4.5L Sterndrive Engine Flame Arrestor Clamp

Models Affected

| Models Covered | Serial Number Or Year |
|-----------------------------|-----------------------|
| All Sterndrive 4.5L Engines | 2A441953–2A446695 |

57543

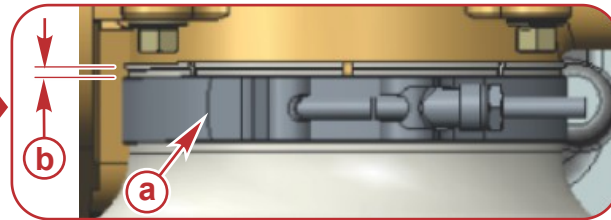
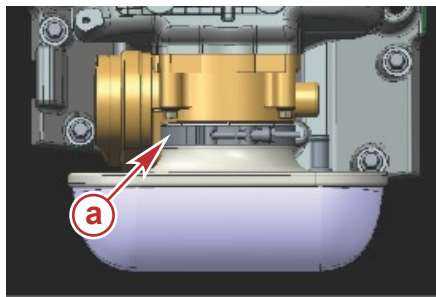
2. Inspect the flame arrestor and clamp position using the location requirements pictured below and reposition as necessary.

- The clamp adjusting mechanism should be at the 12 o'clock location.
- Ensure that the clamp covers the fingers of the flame arrestor and maintains a gap between the lip on the flame arrestor and the edge of the clamp of 0–3 mm (0–0.118 in.).

IMPORTANT: Ensure that the gap is uniform all the way around the flame arrestor.

- a - Clamp
b - The gap between the lip on the flame arrestor and the edge of the clamp

3. Tighten the clamp nut to the specified torque even if you did not have to reposition the clamp.

| Description | Nm | lb-in. | lb-ft |
|--------------------------|-----|--------|-------|
| Flame arrestor clamp nut | 6.2 | 55 | – |
